IREDELL COUNTY HEALTH DEPARTMENT

IMPROVEMENT PERMIT / CERTIFICATE OF COMPLETION / OPERATION PERMIT / EXISTING SYSTEM INSPECTION

OWNER OR CONTRACTOR Terry Cloer PHONE: Business _____ Home 872-3749

LOCATION From Troutman TR Talley Rd. TL Lytton Rd. Lot on L ± 1/4 mile after pavement turns to gravel

INITIAL SITE SKETCH

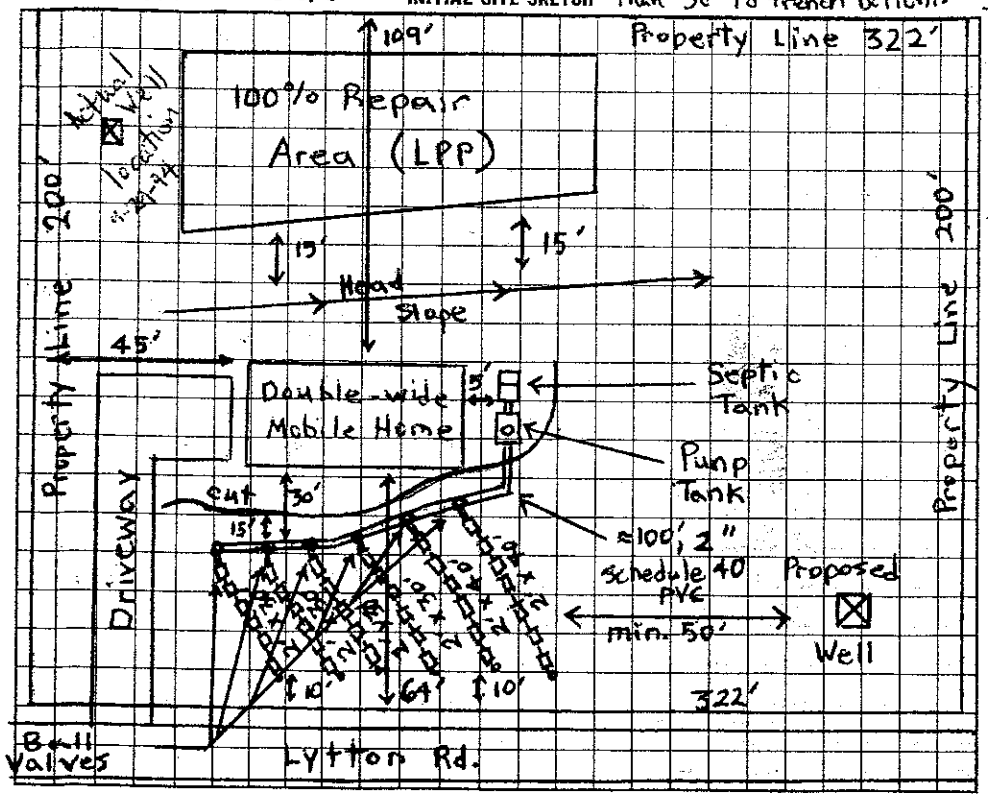
Comments: Permit issued 5-31-94 void due to disturbance of area where original system was to be installed. (cutting). Install 200' of pressure dosed PPBPS. Install PPBPS 8' O.C. and on contour. Keep system 15' from cut, 10' from property lines, and min. 50' from well. Install PPBPS no deeper than 30" to trench bottom. Install pump that will deliver 30 GPM at 20 TDH. (See Attached)

Comments: Checked PPBPS lines, pump, pump tank, septic tank, 2' pressure head, on 9-29-94. Checked floats, NEMA 4X Box, Alarm, conduit sealed, valves in pump tank, and 6" above grade for riser and NEMA 4X Box on 10-19-94. Well located in different area than shown on permit (initial sketch)

Install 46" panels, 1 hole per panel. (3/16" holes)

If system needs repair, 100% Repair Area is too close to well site. May have to abandon well at that time and relocate it.

* Actual well location shown on initial drawing.
